# Technical service bulletin

## Burner Removal & Installation

### Installation Manual Supplement

- The purpose of this bulletin is a supplement to the Servicing instructions for the Buderus Condensing gas boiler Logamax plus GB142-24/30/45/60.

Figure 79a

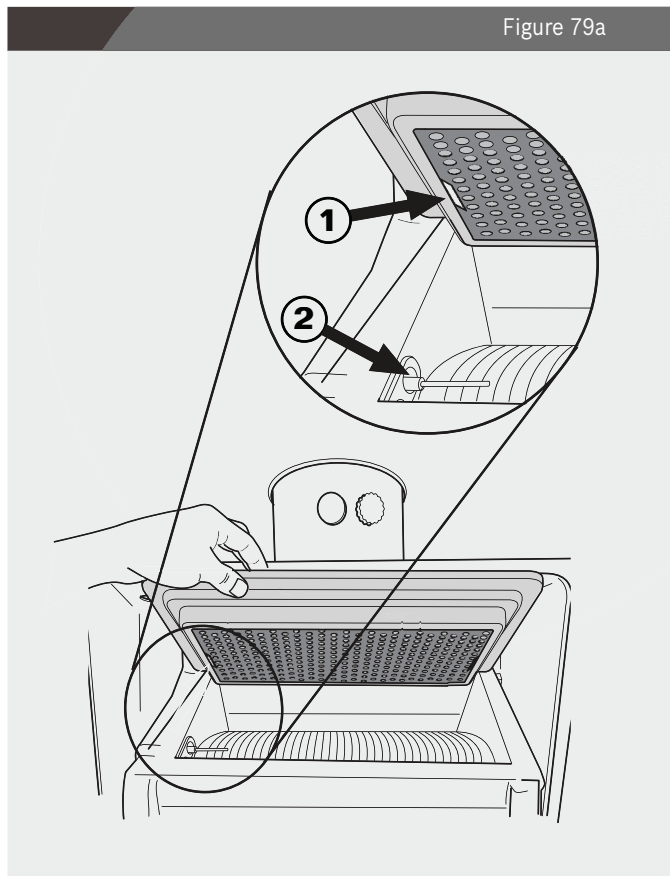
- Install the new burner (see fig. 79a).
- Fit the burner so that the tab (Fig. 79a, pos. 1) is located on the left hand side over top of the ionization rod (Fig. 79a, pos. 2).

**Note:** There is no tab on model GB142/60
